# Access Compliance Report

## Public Rights-of-Way

### (Curb Ramps)

Intersection ID: 11234	Main Street: FLORIDA_AV	Cross Street: SHAMROCK_DR	Location:	N
ADA ID: 73C8C2DA86C2	Ramp Type: Perp	Initial Pass/Fail: Fail	Overall Compliance: No	Severity Score: 12.5
Codes/Mitigation Info/Possible Solution		Field Measurements/Component Compliance

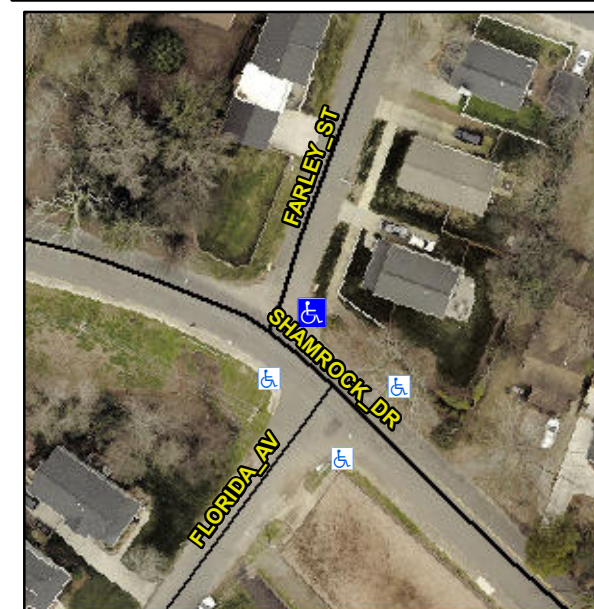
Compliance	Description	Data	Compliance	Description	Data
N/A	Ramp Length (in)	112.5	No	Ramp Slope (%)	10.1
Yes	Ramp Width (in)	82.0	Yes	Ramp XSlope (%)	1.4
N/A	Flare Type LT	N/A	N/A	Flare Type RT	N/A
N/A	Flare Slope LT (%)	N/A	N/A	Flare Slope RT (%)	N/A
N/A	Flare Traversable LT?	N/A	N/A	Flare Traversable RT?	N/A
N/A	Landing Length (in)	N/A	N/A	DWS Provided?	N/A
N/A	Landing Width (in)	N/A	N/A	DWS Contrast?	N/A
N/A	Landing Slope (%)	N/A	N/A	DWS Length (in)	N/A
N/A	Landing X Slope (%)	N/A	N/A	DWS Full Width?	N/A
N/A	Landing Curb? (Y/N)	N/A	N/A	DWS Offset (in)	N/A
N/A	Shared Landing?	N/A			
N/A	Gutter Ponding?	N/A	N/A	Gutter Slope (%)	N/A
N/A	Gutter Lip Ht (in)	N/A	N/A	Gutter X Slope (%)	N/A
N/A	Painted X Walk1?	No	N/A	Painted X Walk2?	N/A
	X Walk 1 Direction	To SW		X Walk 2 Direction	N/A
N/A	X Walk 1 Width (in)	N/A	N/A	X Walk 2 Width (in)	N/A
	X Walk 1 Slope (%)	0.4		X Walk 2 Slope (%)	N/A
	X Walk 1 X Slope (%)	0.7		X Walk 2 X Slope (%)	N/A

**Remove & Replace Entire Ramp.**

**R304.2.2**
